SUBJECT: TECHNICAL SPECIFICATION CHANGES TO ALLOW OPERATION WITH INCREASED CORE FLOW AND PARTIAL FEEDWATER HEATING

RE: LIMERICK GENERATING STATION, UNIT 1

Amendment No. 3  
License No. NPF-39

SAFETY EVALUATION BY THE OFFICE OF NUCLEAR REACTOR REGULATION  
SUPPORTING AMENDMENT NO. 3 TO FACILITY OPERATING LICENSE NO. NPF-39  
PHILADELPHIA ELECTRIC COMPANY  
LIMERICK GENERATING STATION, UNIT 1  
DOCKET NO. 50-352

FIGURE 3.2.3-1a

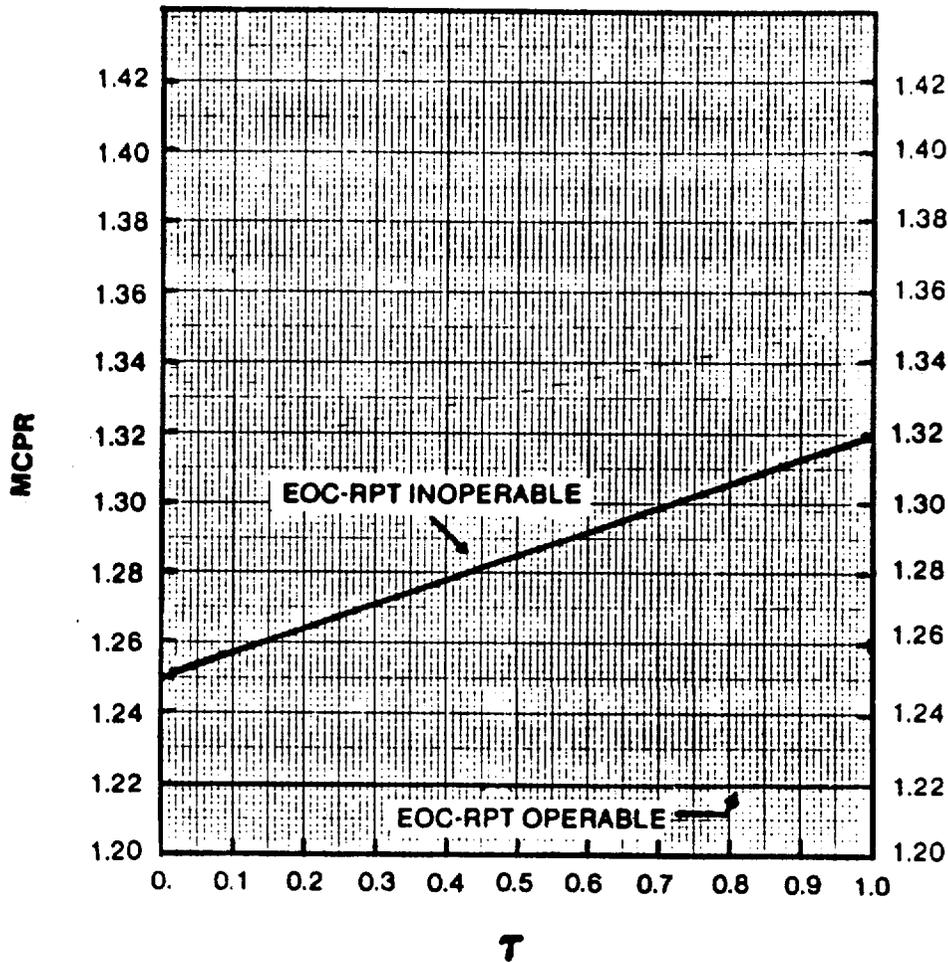
MINIMUM CRITICAL POWER RATIO (MCPR)  
 VERSUS  $\tau$  AT MAXIMUM CORE  
 FLOW < 100% RATED  
 (RATED FEEDWATER TEMPERATURE)

As discussed in Section 2.1 of this Safety Evaluation (SE), changes to the limiting conditions of operation (LCO) are identified for the proposed operational mode. Based on the staff's review, the operating limit MCPRs of 1.24 and 1.28 are found acceptable. The changes are contained on technical specification (TS) pages 3/4 2-8, 3/4 2-9, and 3/4 2-10; TS pages 2/4 2-8a and 3/4 2-10a are added to reflect the modified operation mode.

FIGURE 3.2.3-1b

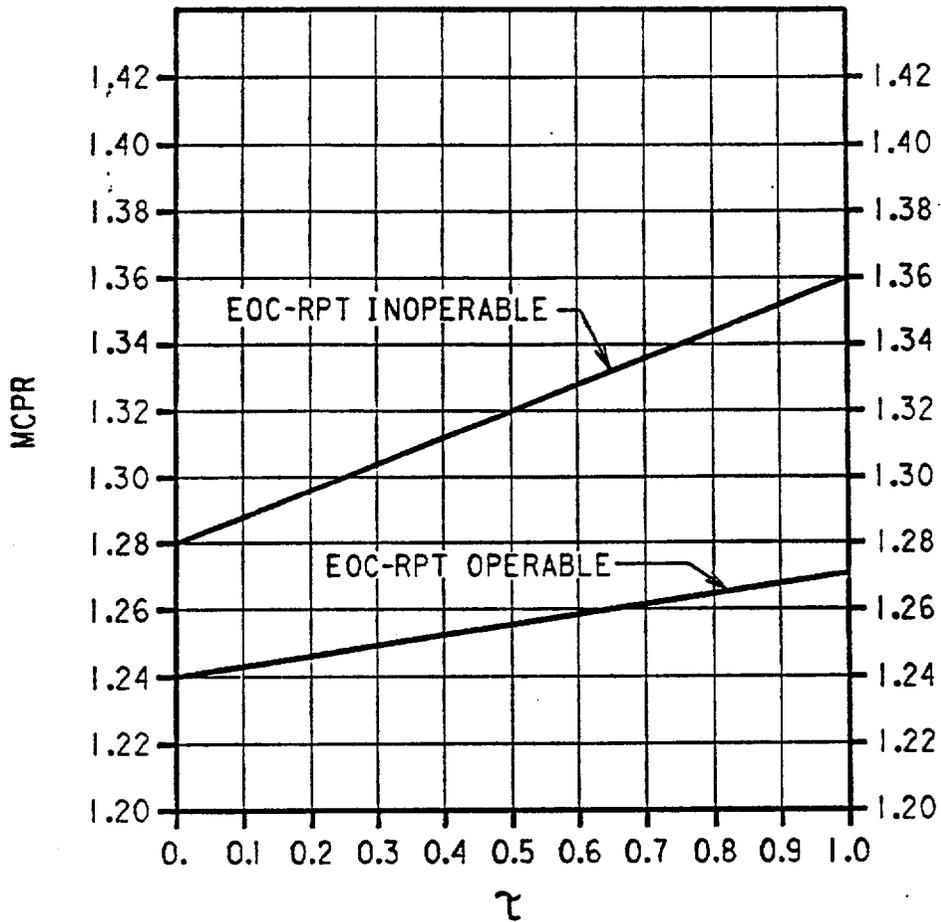
MINIMUM CRITICAL POWER RATIO (MCPR)  
 VERSUS  $\tau$  AT MAXIMUM CORE FLOW  $\leq$  105% RATED  
 AND  
 MAXIMUM FEEDWATER TEMPERATURE REDUCTION  $\leq$  60°F  
 AT RATED CONDITIONS
